MODIFICATION FOR RE-BID #1

Governor's Office of Storm Recovery Oceanside Fire District Headquarters Storm Hardening Rebid CR38 General Construction Project Number 3341409999

THE PURPOSE OF THIS ADDENDUM IS TO CHANGE THE FOLLOWING ITEMS:

Date: 07/23/19 Scale: NTS Code: TIA-222-G Phone: 315.524.2531 Dwg No. E-1 FAX: 315.524.4249

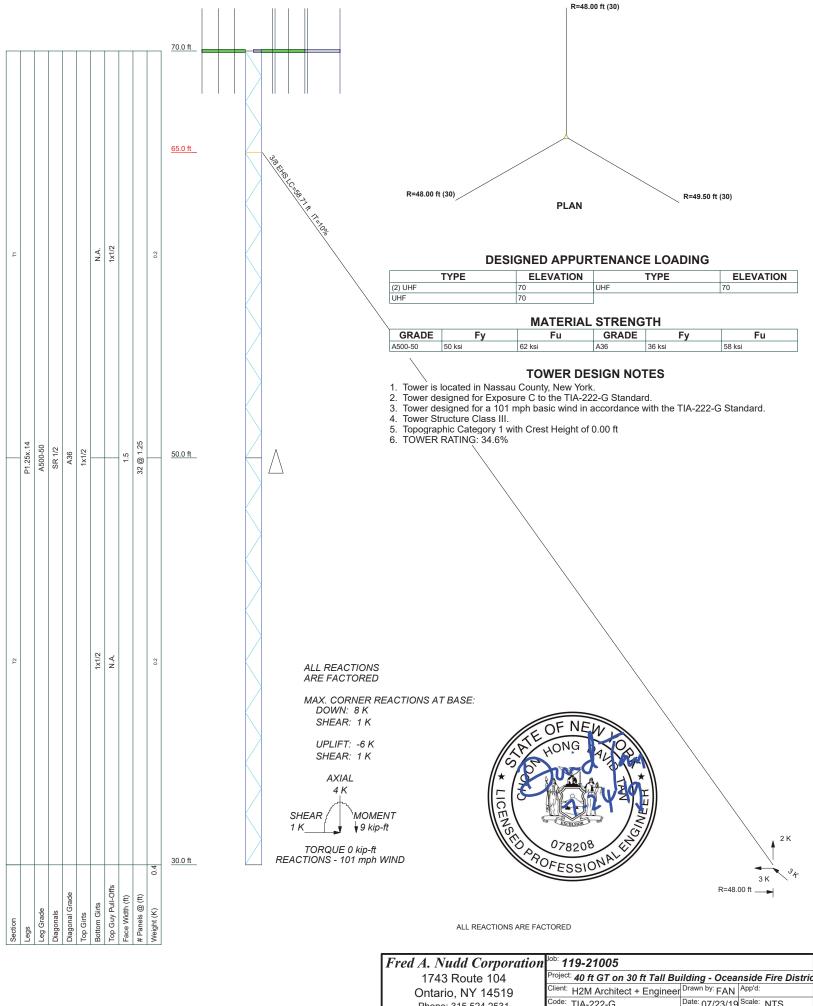
Item No. 11, Clarification to Antenna Design – See attached proposed Antenna basis of design, the contractor is responsible for providing signed and sealed design documents to architect/engineer for review/comment during the shop drawing process.

Item No. 10, Clarification to Antenna Design – Owner, "Oceanside Fire District" will provide all equipment to be mounted on the proposed radio tower. The Contractor shall coordinate the required equipment with the Owner prior to design. Contractor will be required to mount District provided equipment to proposed tower.
